REVISED RESPONSE TO REQUEST FOR ADDITIONAL INFORMATION**APR1400 Design Certification****Korea Electric Power Corporation / Korea Hydro & Nuclear Power Co., LTD****Docket No. 52-046**

RAI No.: 167-8191

SRP Section: 09.01.01 - Criticality Safety of Fresh and Spent Fuel Storage and Handling

Question No. 09.01.01-2

Figure 3.7.16-1 (page 1 of 1)
Discharge Burnup vs. Initial Enrichment for Region II Racks

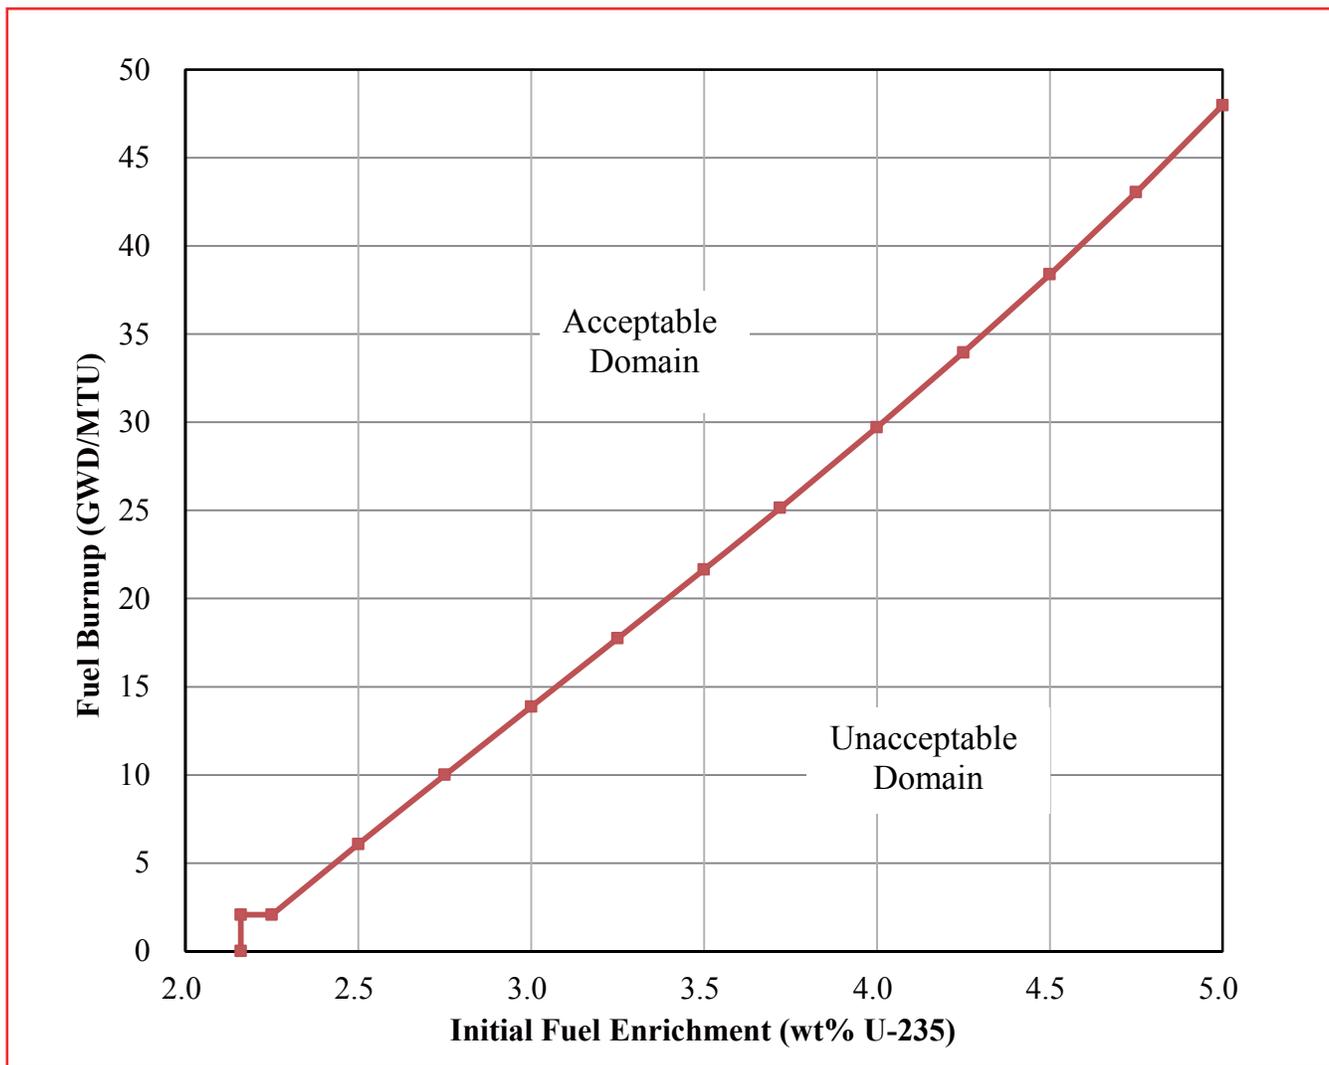
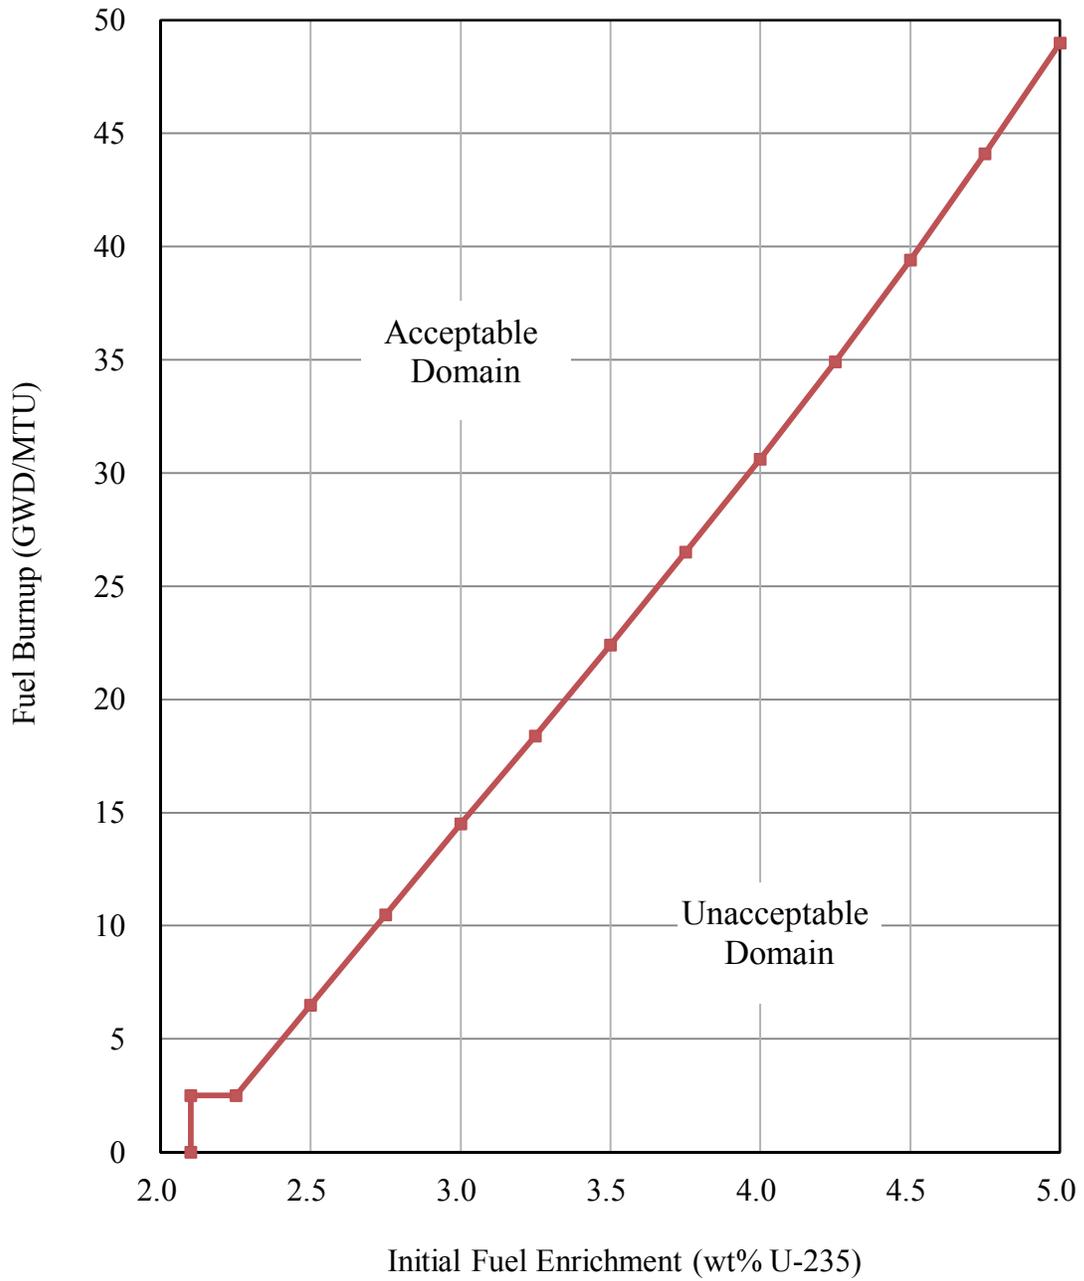
Figure 3.7.16-1 of technical specifications will be revised as indicated in Attachment 2.

This figure should be replaced with the figure in the next page.
